APPENDIX H GOVERNMENT ARCHITECT'S ADVICE

RE: Revised PPR for Rozelle Village, Major Project Application (MP11-0015)

Rozelle Village, Major Project Application (MP11-0015): Design Review 2.

ROZELLE VILLAGE – INDEPENDENT DESIGN REVIEW

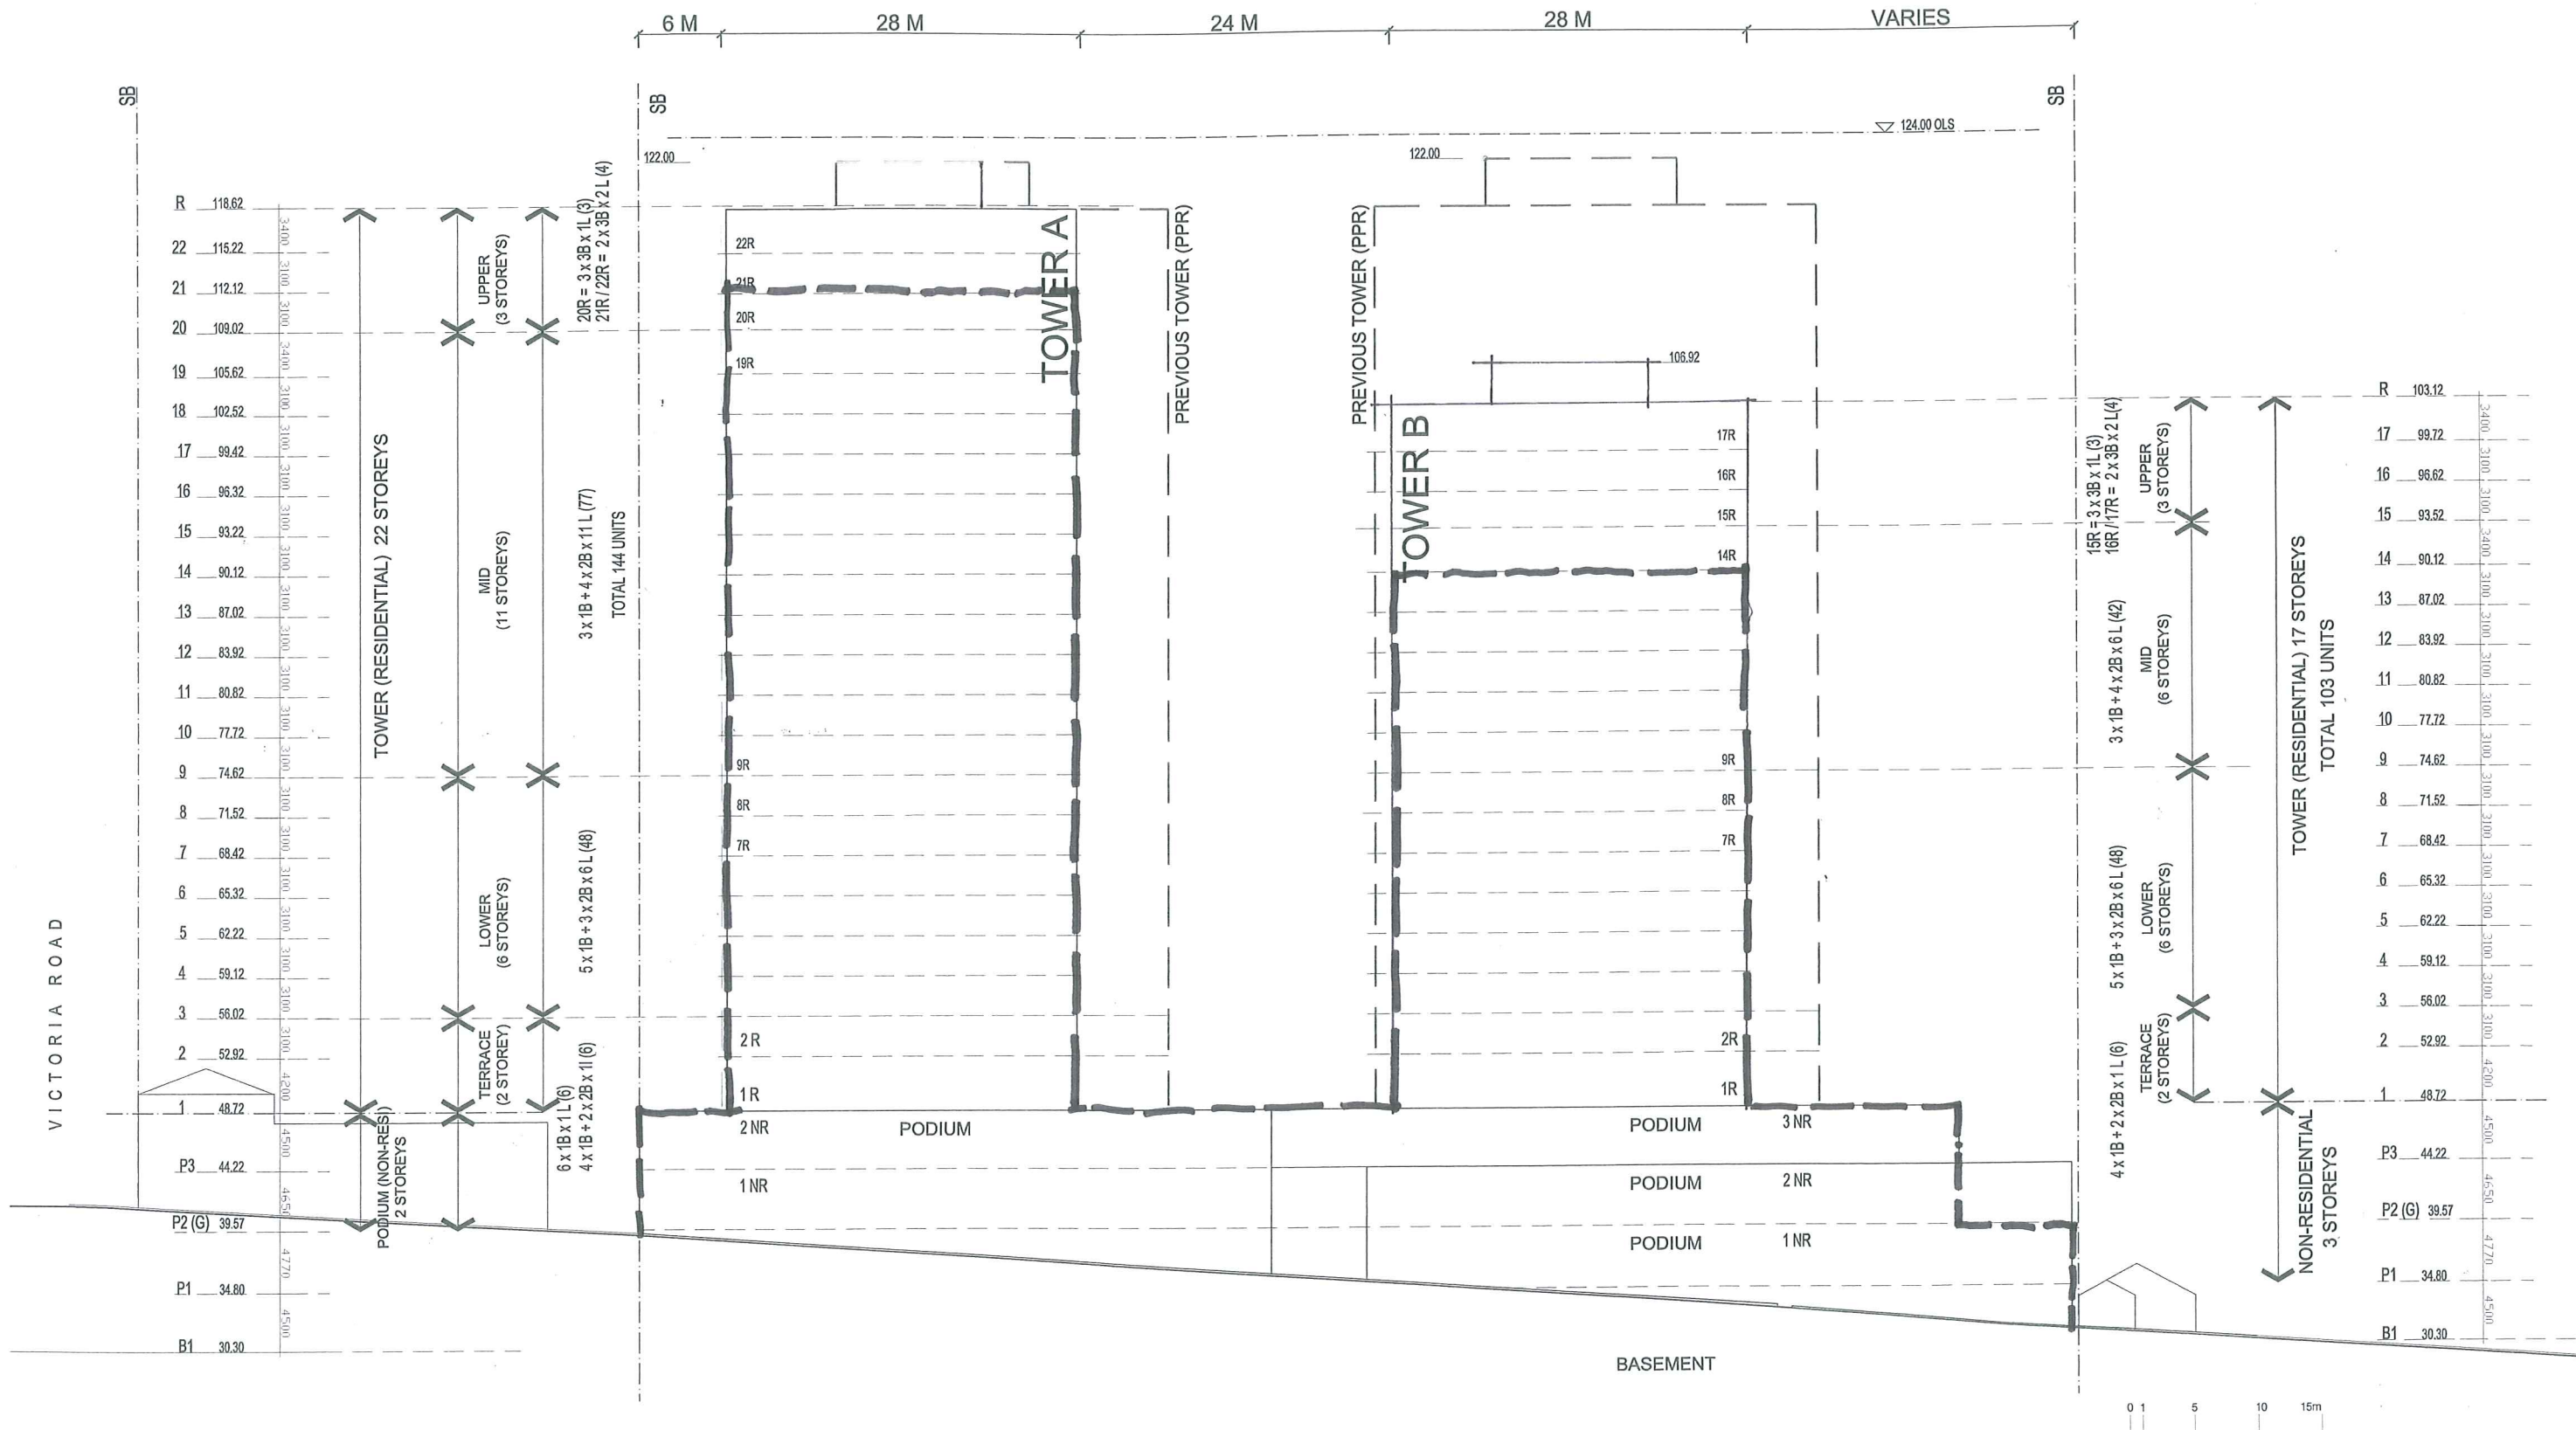
- The tower facades are still repetitive and generic, lacking in modulation that could assist in diminishing the scale of the development.
- The 'vertical emphasis . . . to reduce (tower) bulk' (p12 PPR) is not successful. The potential for vertically expressed bays and recesses to diminish scale is lost because the limited range of materials and finishes makes the facades very bland.
- a high proportion of external finish is glass or metallic, resulting in hard, reflective surfaces that are more suited to commercial office block development.
- The resolution at the top of the towers – roof top plant areas are up to 4 stories high and consist of an awkward mix of concrete, glass and Al louvred screens, which are most visible from the south.

To mitigate the tower bulk the following are recommended:

- a. **Variety** - towers should not be identical. The following could be considered:
 - Stage a design competition for the tower facades, with separate designers to be selected for each tower. The competition scope should include but not be limited to:

- b. **Visually minimise** the bulk and width of the towers, and emphasise slenderness. The following could be considered:
 - Adopt a wider range of materials and elevation treatments to distinguish tower bays from one another (see images below)

- Operable elements such as louvred and sliding panels
 - more elements that create shadows eg sun shading, especially on west facing elevations
- c. **Diminish vertical** appearance of identically stacked slabs and balconies. The following could be considered:

- Varied balcony design eg staggered placement, enclose balconies randomly or on alternate levels, vary balcony depths
 - Strategically conceal slab edges in selected locations – to create larger blocks of colour and scale as a contrast with the finer grain.

- Introduce floor setbacks ('waists') every 5 or 7 floors.
- d. **Review** Plant room design. Suggestions include:
 - Reduce number of materials
 - integrate composition as part of tower design, not a separate entity (refer to Attachment 3)

Fig 1: recommended podium height and setbacks

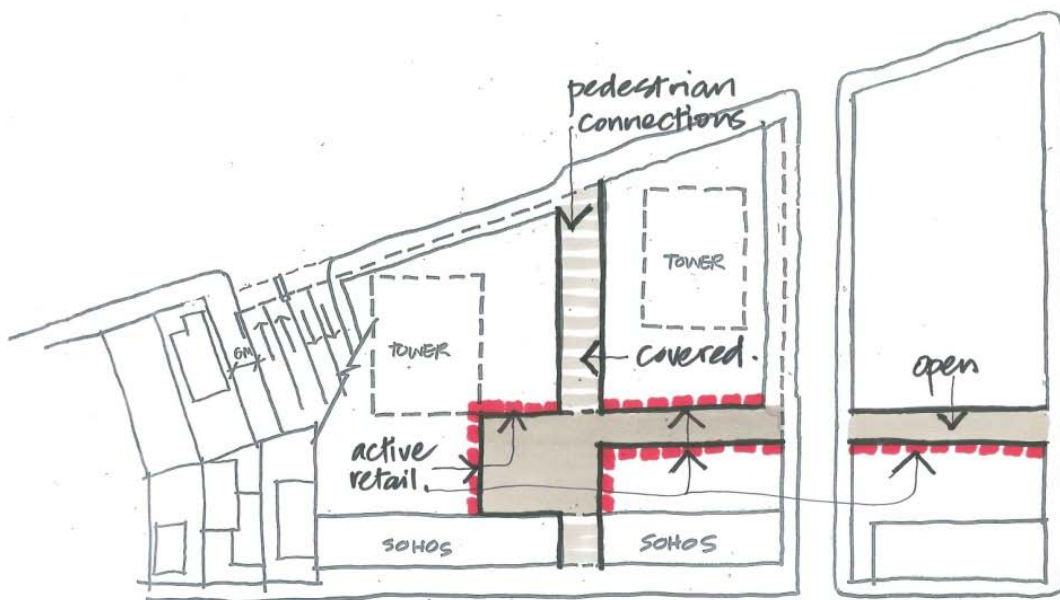
- As the site has a dual frontage, there is an opportunity for connecting cross streets to be created. ie an extension of Darling lane. Set back podium to create a thru site, on grade connection between Victoria Rd and Waterloo St. Refer to Figure 1.

- Height of podium should be reduced at NW end of site. Refer to Figure 1.
- Provide active retail uses along through site links and connections. Refer to Figure 2.

Fig 3: recommended vehicle access

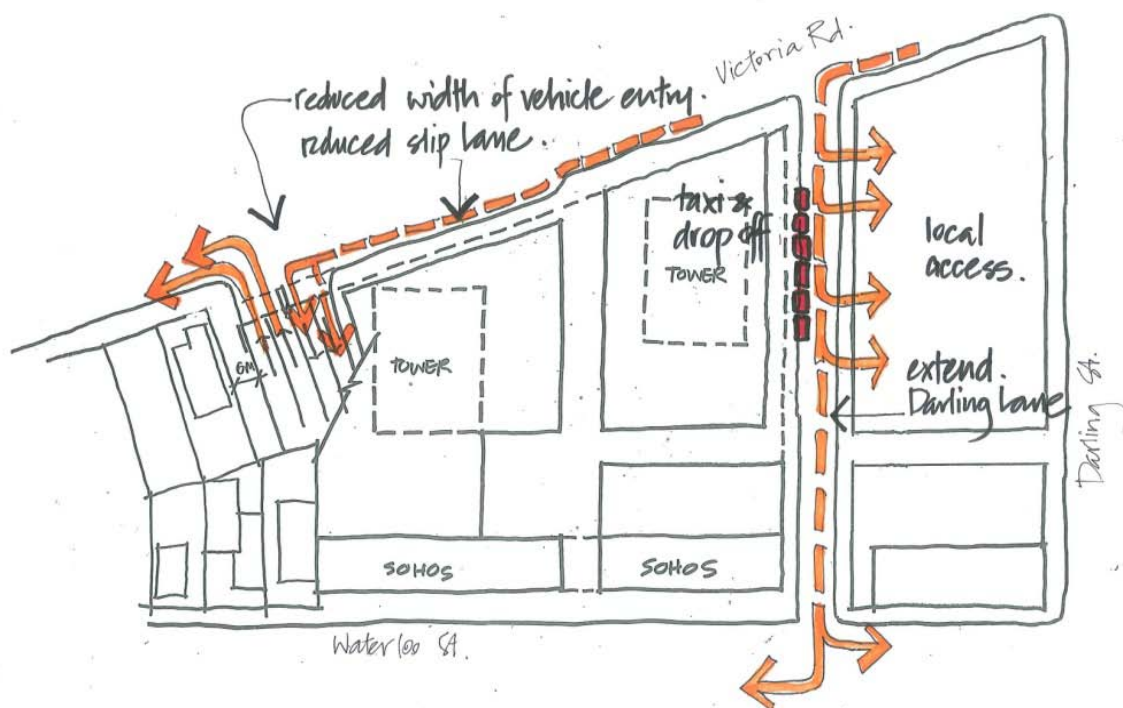
- Modify and shorten the proposed slip lane on Victoria Road to remove unsuitable chicanes and replace with a conventional LH corner turn into the driveways at the NW end of the site. Refer to Figure 3.

- Consider one way traffic movements for new thru site link to minimise disruptions to Victoria Rd. Refer to Figure 3.
- Taxi and drop off zone should be along Darling Lane extension, not concealed within building envelope.

Fig 4: indicative pedestrian access

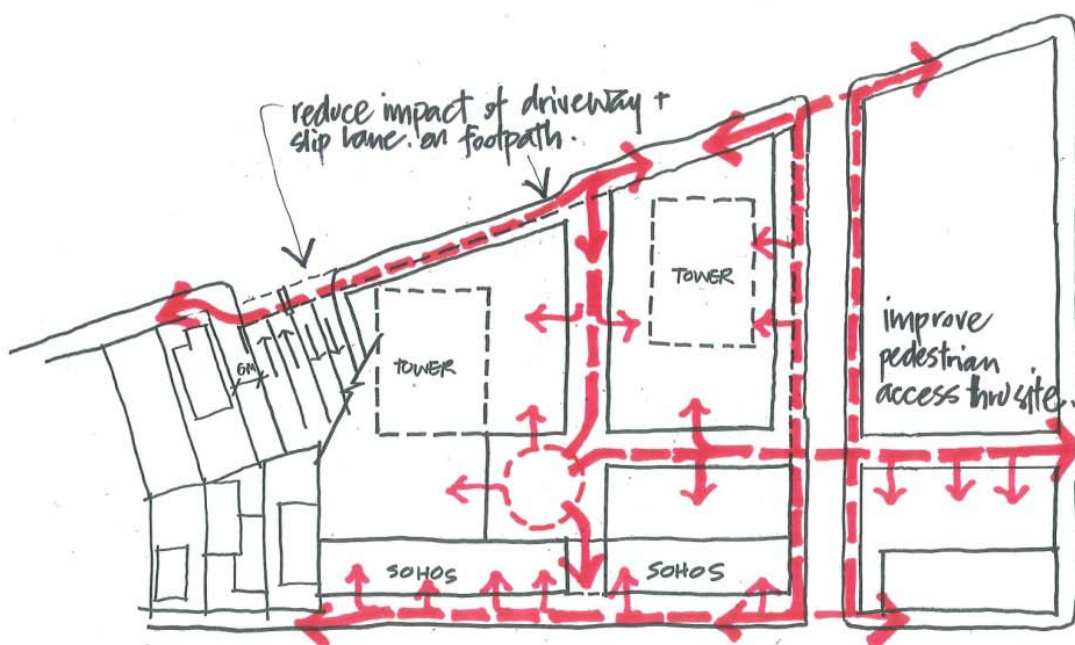
- Align thru site links and pedestrian connections to improve permeability and legibility for pedestrian access. Refer to Figure 4.
- Provide accessible footpaths to both sides of Darling Lane connection. Refer to Figure 4.

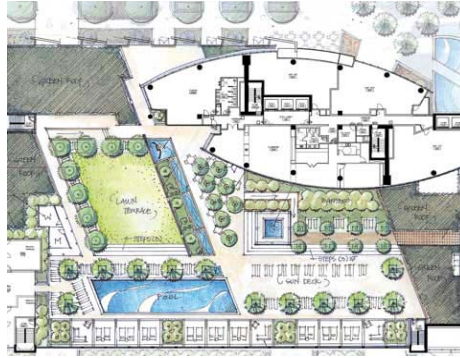
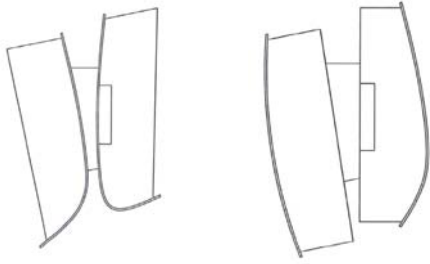
- The site is a 'gateway' to the Balmain / Rozelle peninsula but the application does not demonstrate how the design reflects the character of the area,
- The proposed tower designs adopt the generic language of most other apartment buildings.
- Tower frontages are almost identical with a bland and repetitive fenestration and balcony composition.
- Unarticulated and blank tower facades are unsuited to high wind situations.
- Podium does not integrate well with the site topography, with extensive blank frontages where internal levels don't meet footpath levels.
- Podium finishes and fenestration are not well integrated with local building character.

- Express the two towers as separate but related identities.
- Vertical articulation and modelling to reduce visual bulk.
- Use materials which reflect the robust character of the existing urban setting.
- Tower frontages should respond to different orientations eg deep shading to west facing elevations.
- review the 'peach' colour palette of the podium and the generic colour palette of the residential towers
- podium articulation and fenestration should be reviewed to better integrate with adjacent development and site topography.
- Facade articulation to mitigate wind impact. Suggested treatments include:
 - Articulation to dissipate wind turbulence, eg staggered balconies
 - Changes to building shape: curved building faces can deflect wind flows
 - Orientation: facing the narrower frontages to the SW will reduce turbulence
 - Use of awnings to deflect turbulence at ground level
